NINE-MILE POINT-NUCLEAR STATION, UNIT 2

AMENDMENT TO-FACILITY-OPERATING-LICENSE

Amendment No. 19  
License No. NPF-69

AMENDMENT NO. 19 TO FACILITY OPERATING LICENSE NO. NPF-69

Figure 4.7.5-1 Sample Plan 2 for Snubber Functional Test

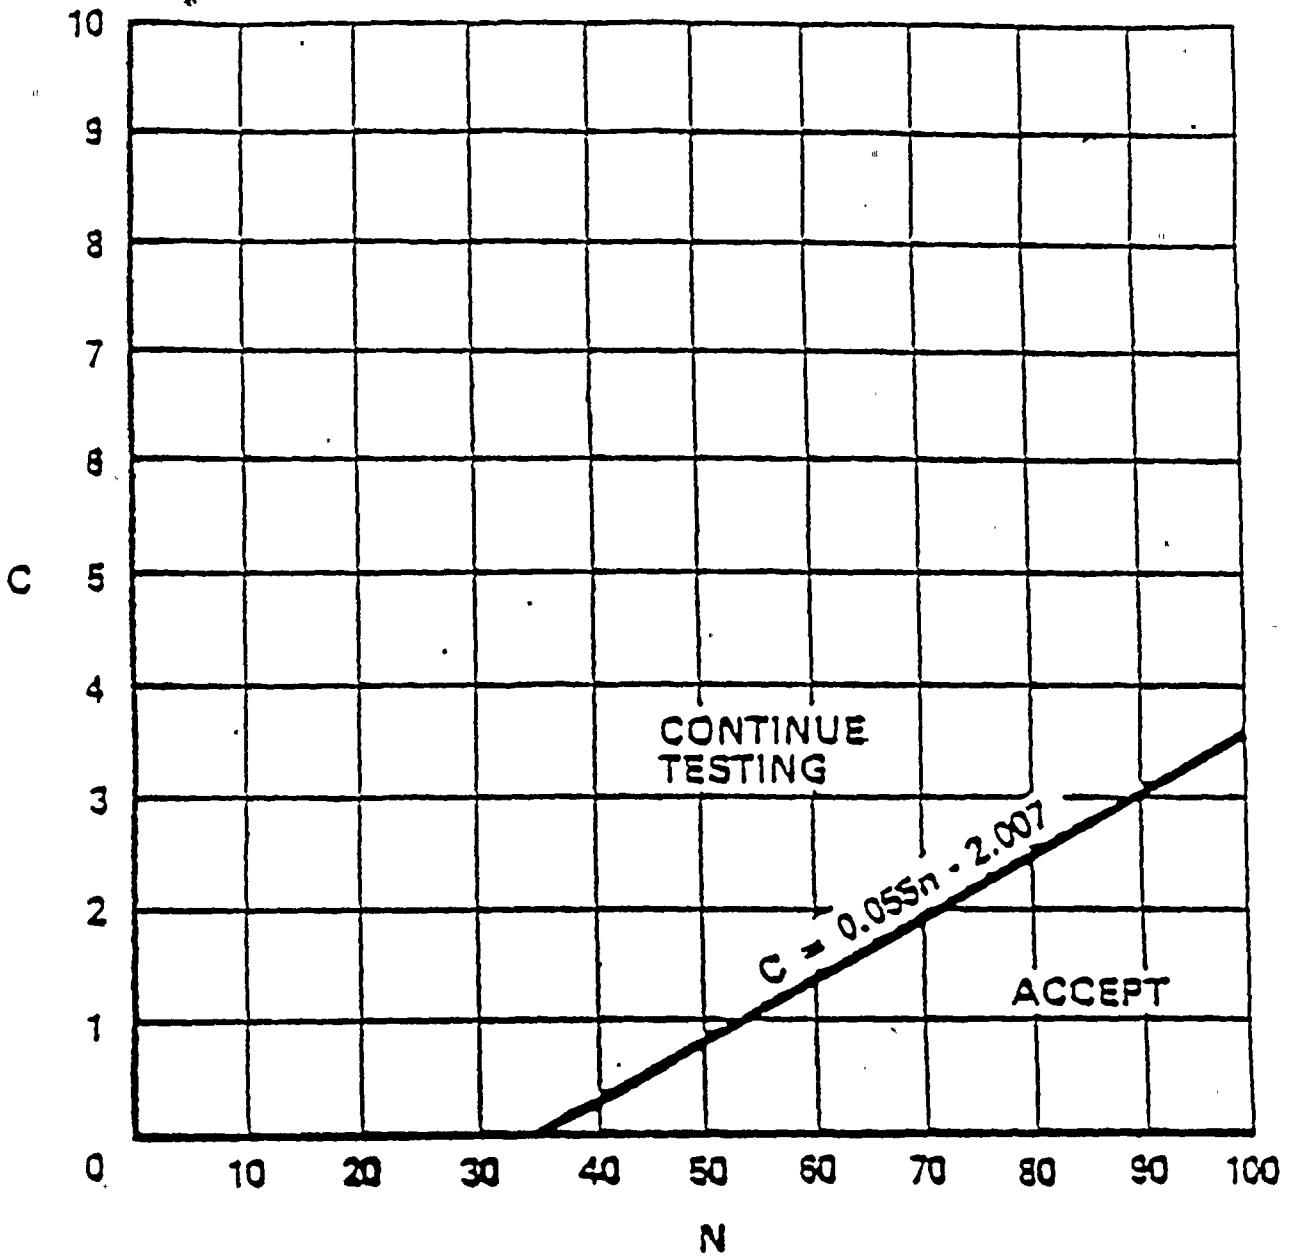
2. An initial representative sample of 37 snubbers of each type shall be functionally tested in accordance with Figure 4.7.5-1. "C" is the total number of snubbers found not meeting the acceptance requirements of Specification 4.7.5.f. The cumulative number of snubbers of a type tested is denoted by "N". If at any time the point plotted falls in the "Accept" region, testing of snubbers may be terminated. When the point plotted lies in the "Continue Testing" region, additional snubbers shall be tested until the point falls in the "Accept" region or all the snubbers of that type have been tested.
